**ADDENDUM NUMBER TWO (2)  
TO THE PLANS AND SPECIFICATIONS FOR:**

**NORTH ECHS  
AND  
COLLEGE & UNIVERSITY CAMPUS  
STUDENT RESTROOM RENOVATIONS**

**PSJA ISD  
Bid # 18-19-042  
Project No. 19.04**

**GIGNAC & ASSOCIATES  
3700 N. 10<sup>th</sup> STREET, SUITE 205  
McALLEN, TEXAS 78501  
(956) 686-0100**

MD2.12U

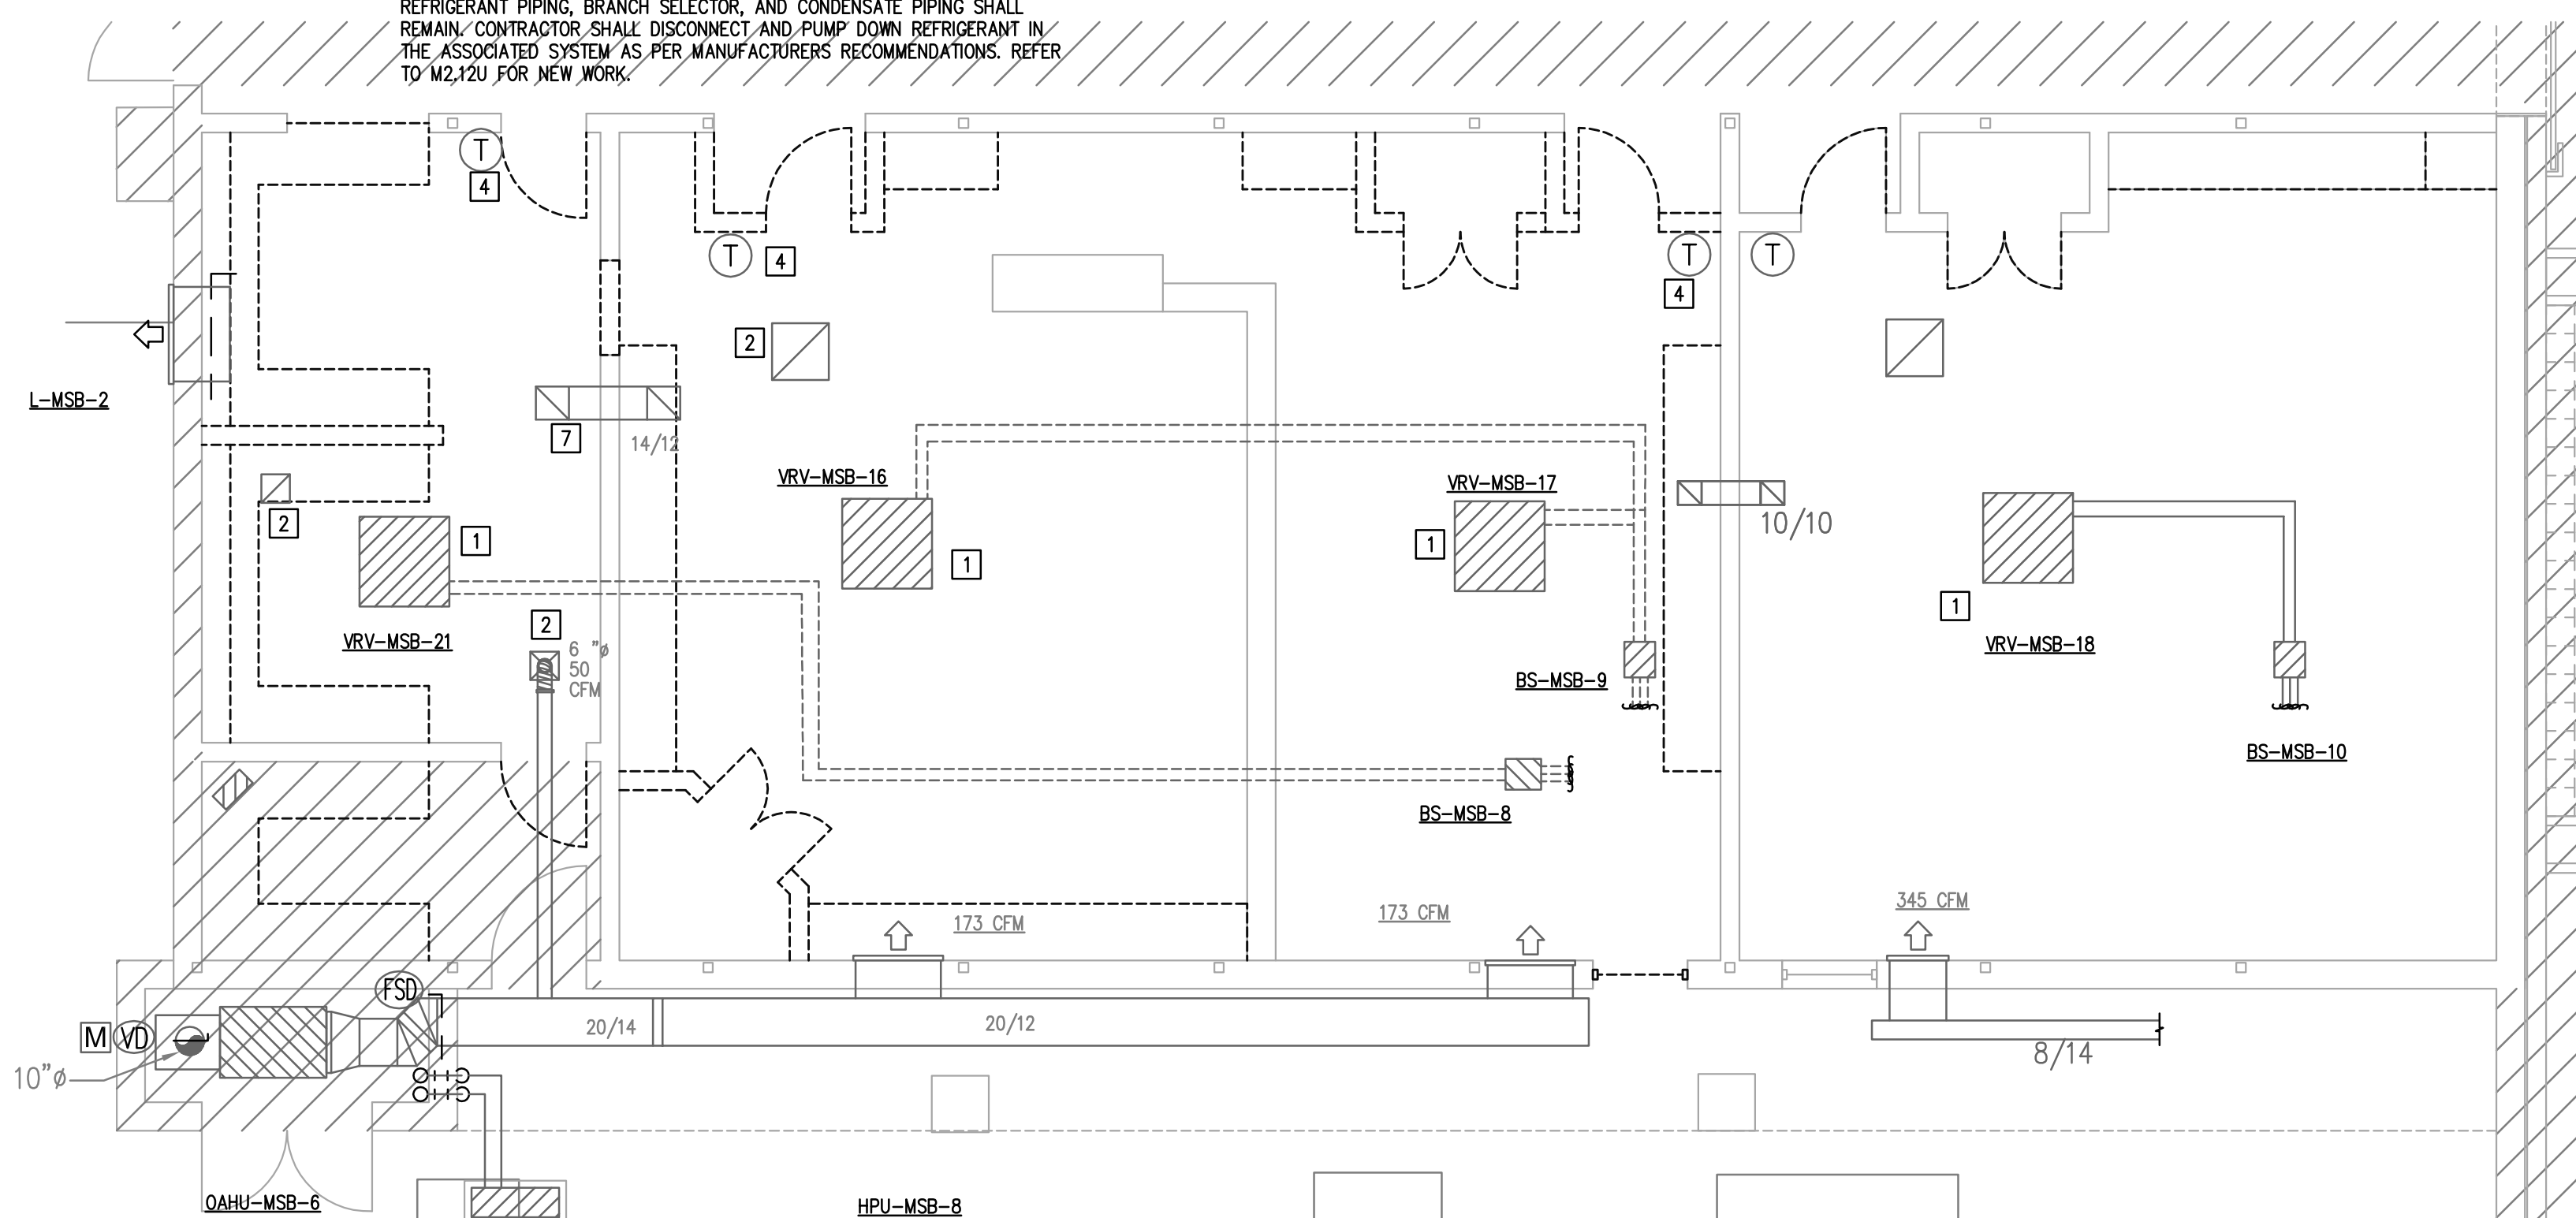
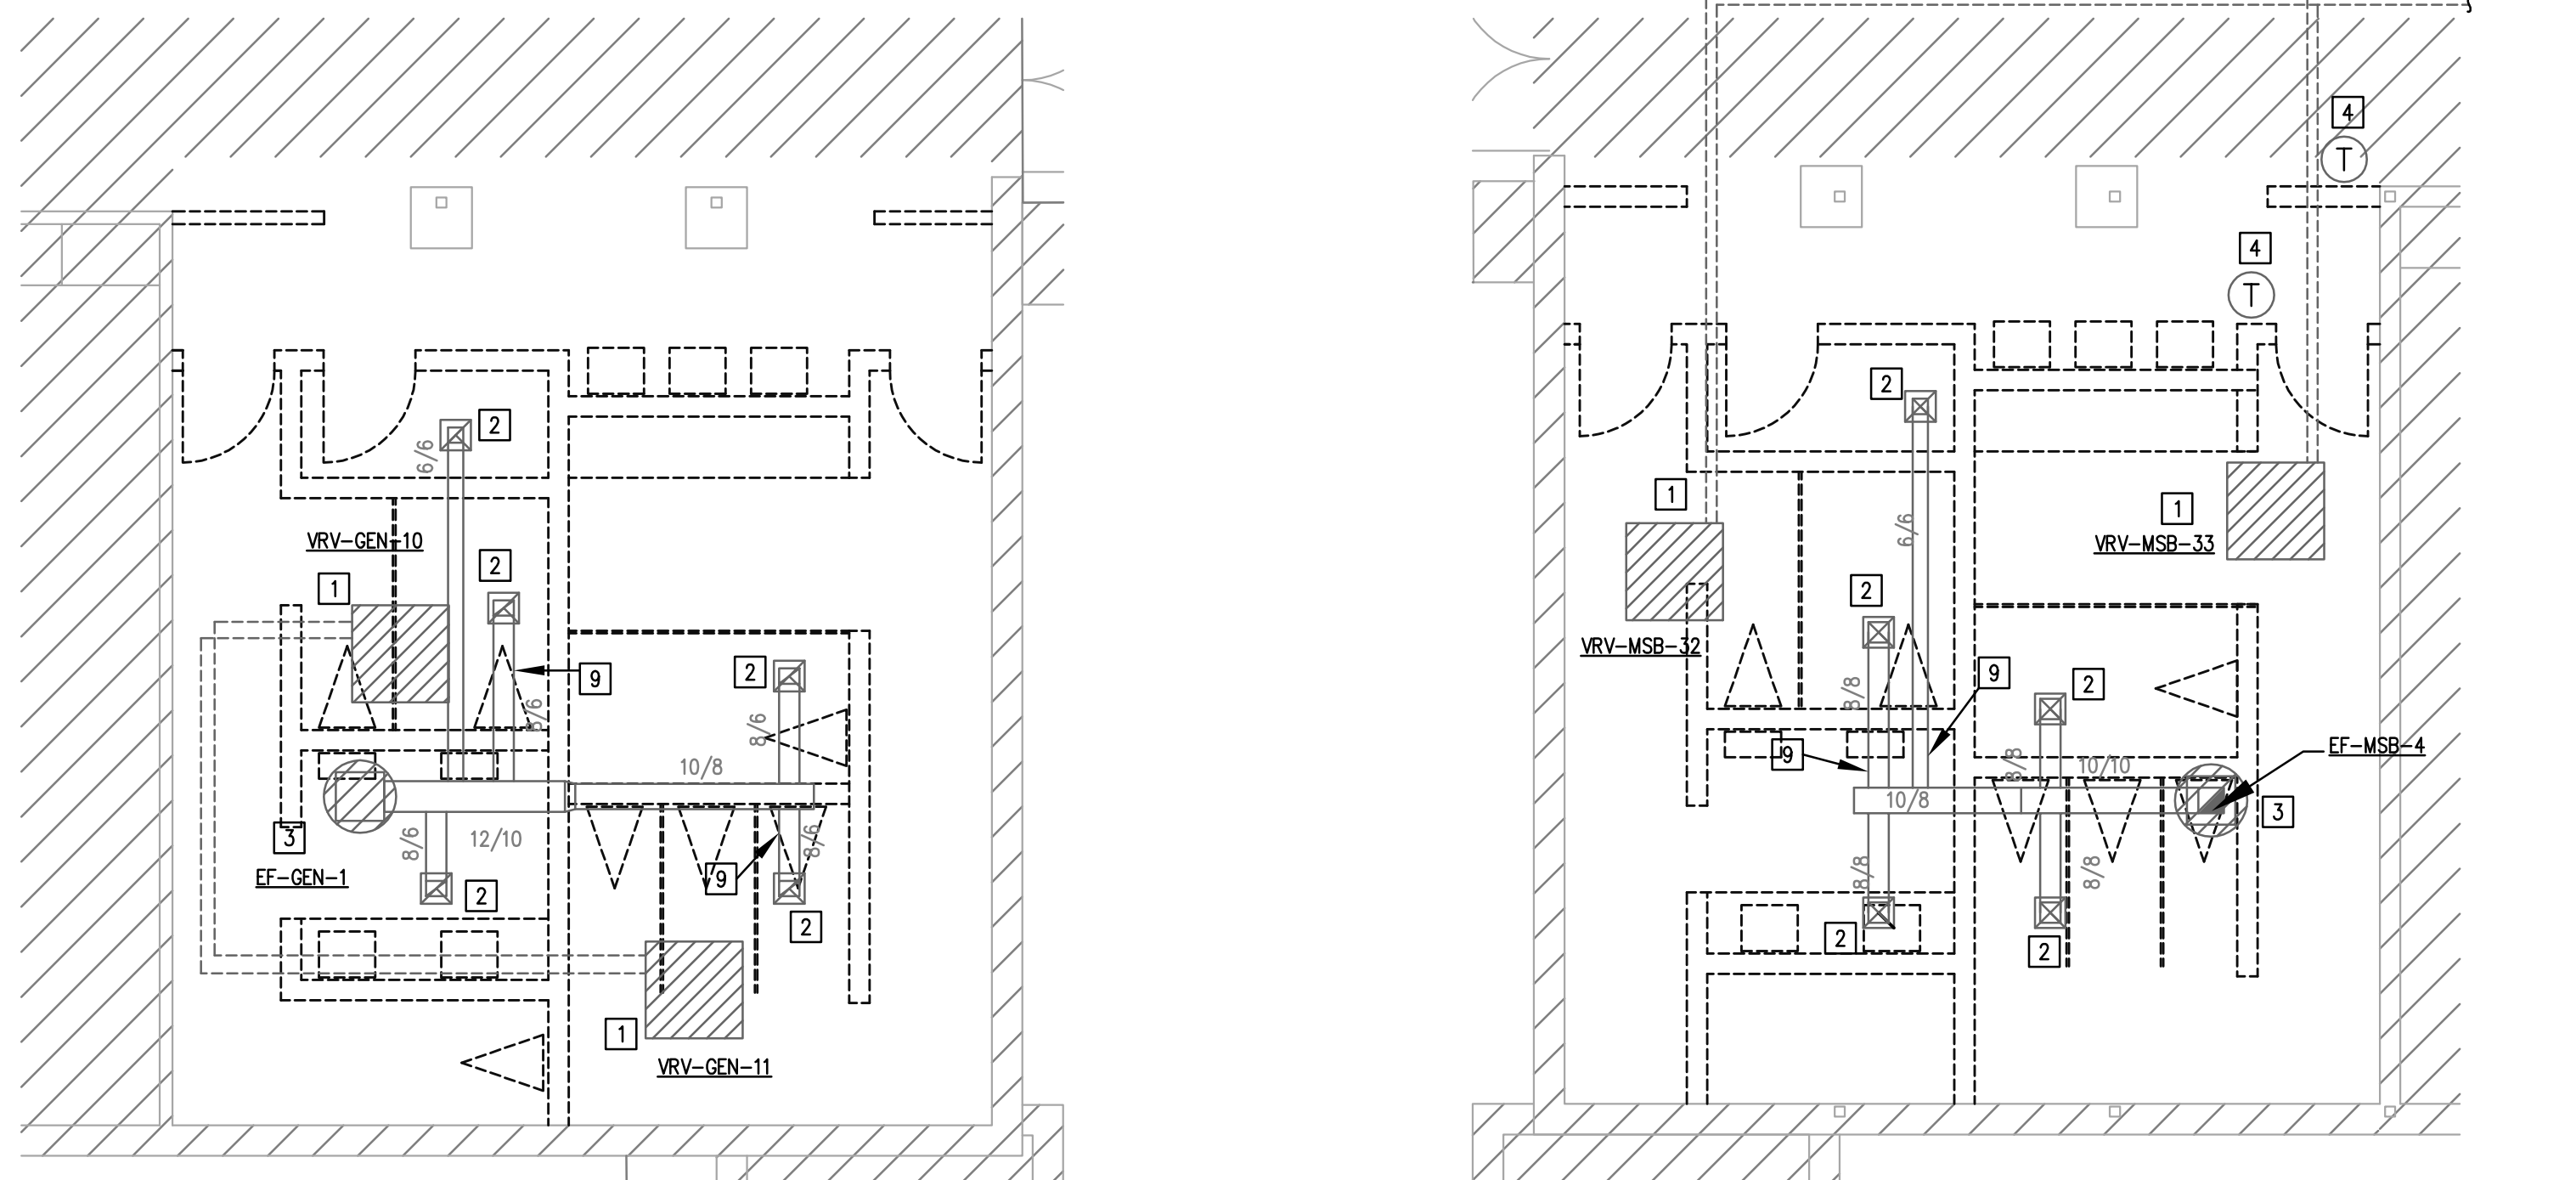
- A.      Outside air units to remain and all associated ductwork and air devices shall not be removed and noted to be relocated. Transfer ducts to be relocated. Re: MD2.12U.
